CITY OF LAS CRUCES

SUBJECT: Case 26RB2004618 and 26OC1504639

Case 26RB2004618 and 26OC1504639: A request for a Certificate of Appropriateness for the rehabilitation of a property at 425 E. Mountain Avenue. The subject property is zoned R-3; property owner is seeking approval for the replacement of all windows, outright removal of two windows, rear addition to the property including three new windows, and the installation of metal standing seam on the roof. The replacement windows and rear addition were constructed outside the City's permitting process; the roof was approved without consultation by the Historic Preservation Program; all are presented for retroactive approval to the Historic Preservation Committee (HPC) by way of acquiring a permit. The building was constructed between 1940 and 1950 and captured within the State Register Historic District listing for the Mesquite Street-Original Townsite but is not contributing to the State Register Historic District listing; it is within the South Mesquite Overlay (SMO). An application for a retroactive permit for construction has been submitted by the property owner, Carlos Almaraz, with retroactive drawings developed by staff at

Figure 16: Slider on north side of west façade; two windows have been removed.

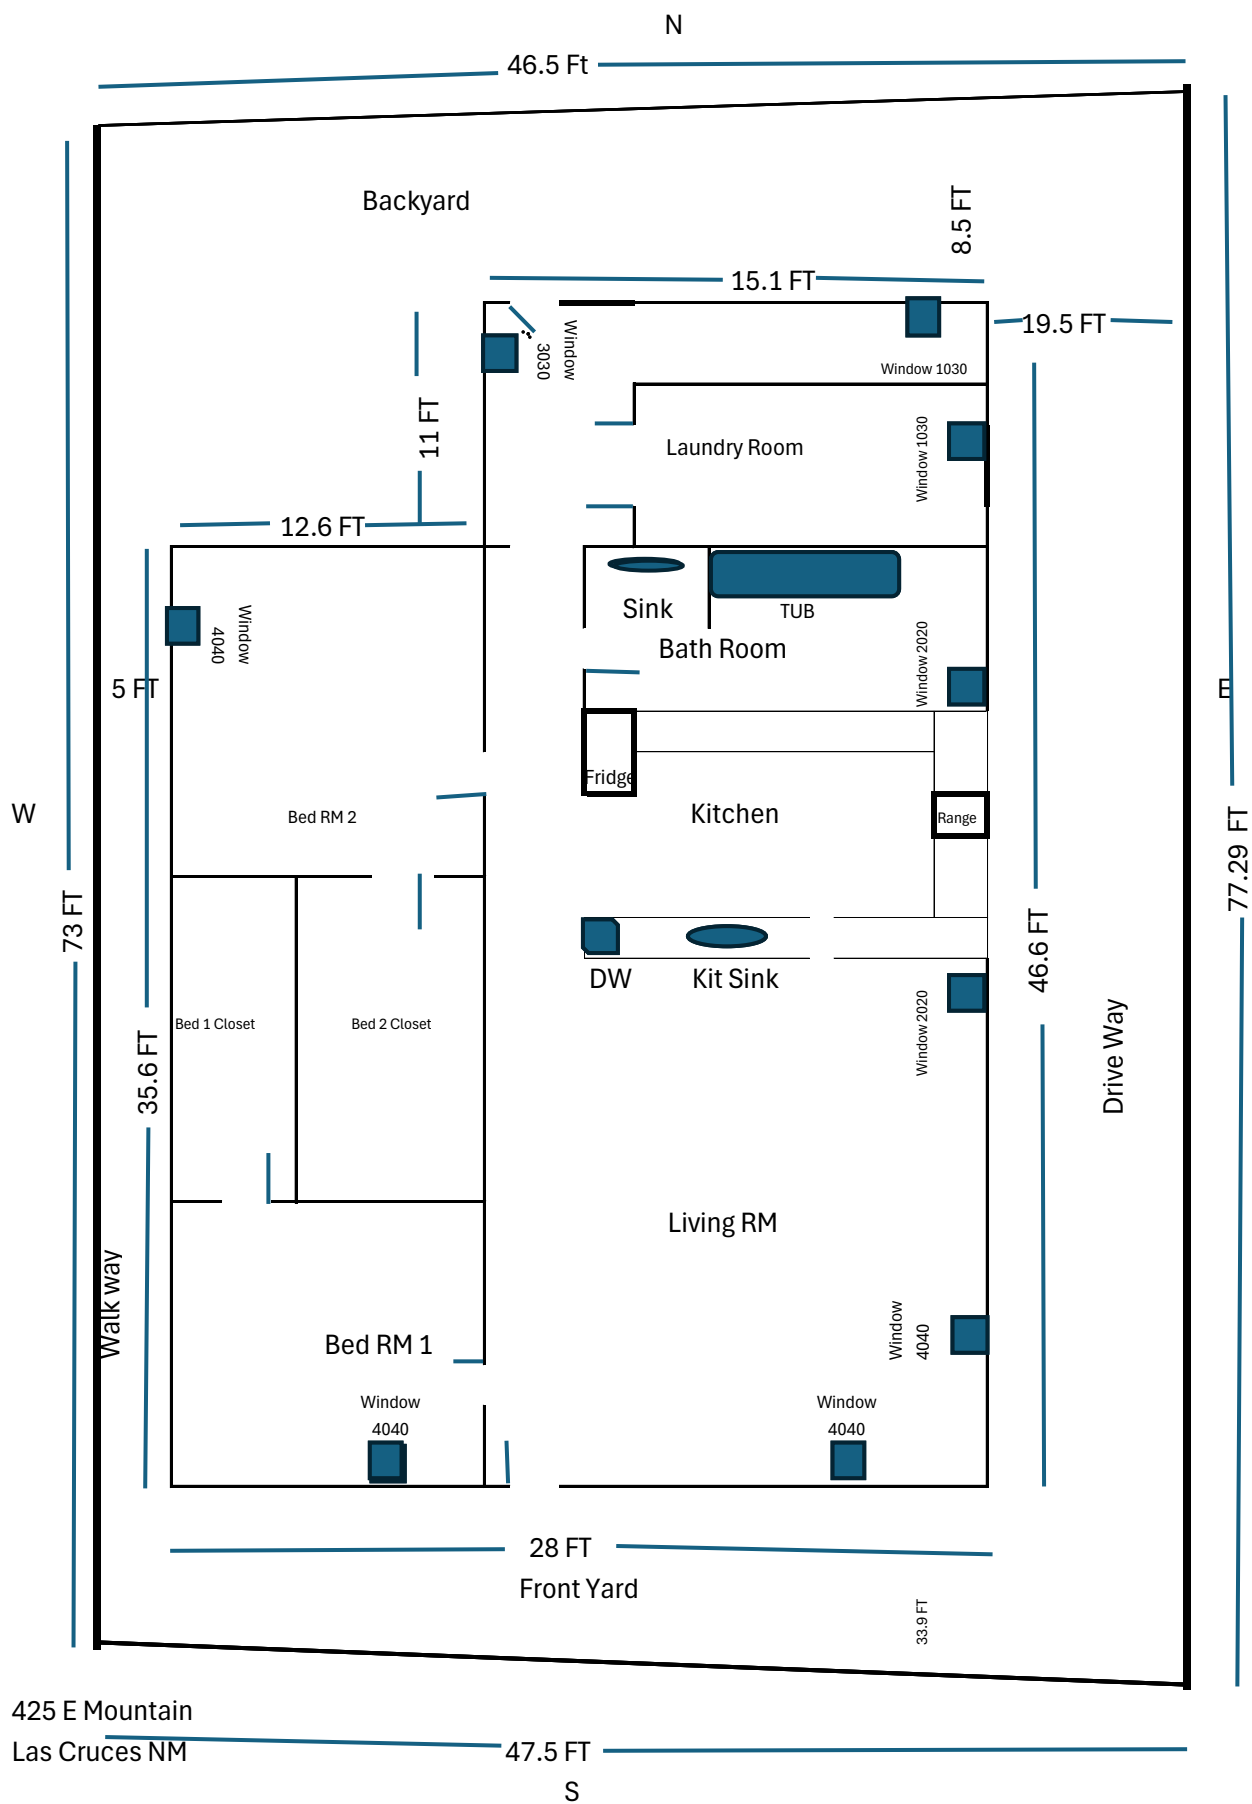
Window replacement in Las Cruces requires permitting regardless of the property's location; if located in the SMO, window replacement must go through the HPC. The original windows at 425 E. Mountain were a variety of steel casements, specifically large picture windows to the front with progressively smaller windows to the rear more private rooms. The replacement windows neither fit the dimensions of the original windows, nor is the window operability the same, with all operable replacement windows functioning as sliders rather than casements. On a contributing property, both these issues would result in an immediate loss of contributing status, stemming from the loss of historic integrity. Additionally, the earlier owner removed a side entrance to the driveway and replaced it with a window, which would also be disqualifying for a contributing property. However, the property at 425 E. Mountain is not contributing, which softens the impact of these changes. The National Park Service's Preservation Brief No. 13 provides directions on repairing and upgrading historic steel windows.¹ For historic properties with steel windows from the late-1800s/early-1900s, steel windows have been maintained and survived the lifespan of the building – for the property at 425 E. Mountain, this is between 70 and 80 years; by comparison, vinyl replacement windows will deteriorate and fail around 20 years, depending on frequency of use and the climate. Modern windows are often touted as being more environmentally friendly than older ones, with window companies promising property owners lower energy bills. A simple understanding of a manufacturing cycle, taken with the lifespan of the replacement windows, shows this is not the case. Manufacturing new windows out of new products, whether that's oil-based or natural resource-driven, places additional strain on the environment; the fact that these windows cannot be repaired means that more windows will have to be manufactured in the future. The cost of window replacements is similarly inefficient: the amount saved in energy bills compared to the cost of the window itself often means the replacement window would have to outlive its lifespan to actually save the property owner money – this is when we posit that a vinyl window never ceases to be effectively efficient, which is not borne out by evidence. For more information, please follow the link below.²

FLOOR PLAN: ADDITION

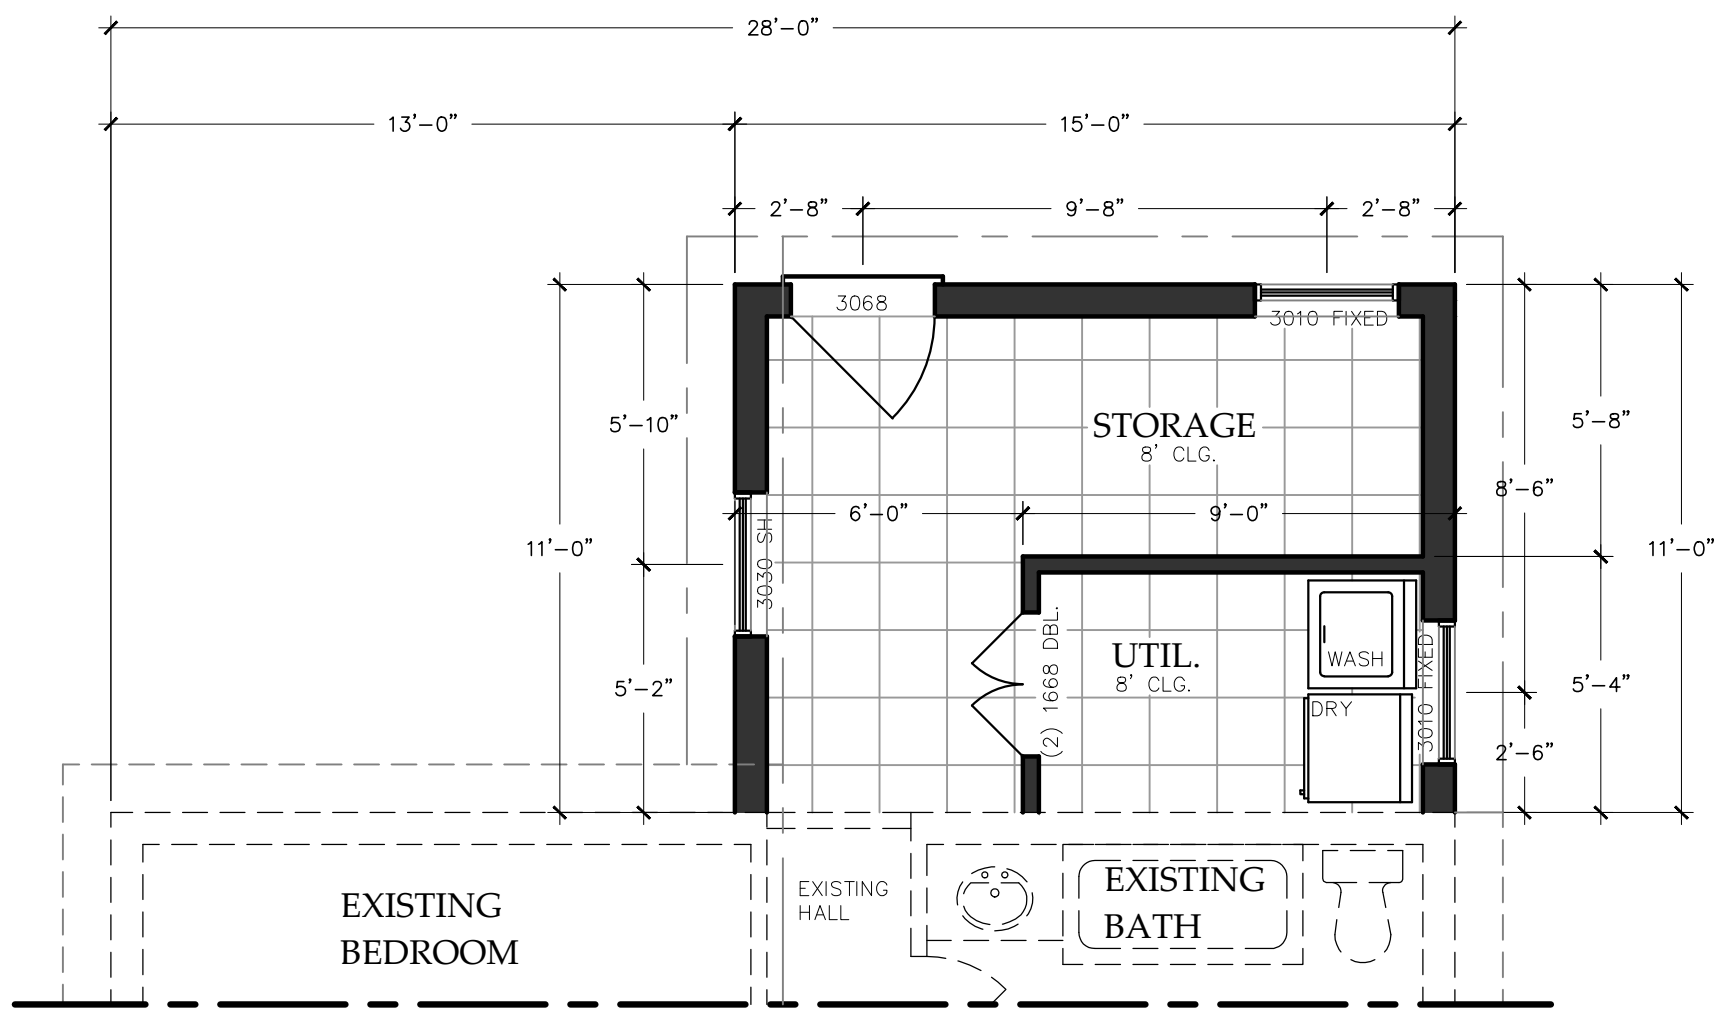
The rear addition introduces a utility closet for washer and dryer with additional storage space. The addition is approximately 11' x 9'8" with three new windows, a slider on the west façade and clerestory windows on the north and east sides of the addition. The

construction of the addition included the removal of the side door that accessed the driveway; a door was installed on the north side of the addition. Additions to historic buildings are generally to be constructed without a shared roof line, providing some visual evidence that the addition is distinguished from the original construction.

2. The addition of the rear utility room meets the minimum required by the Secretary of the Interior Standards in that it was constructed to the rear of the property and is less visible from the street-view.
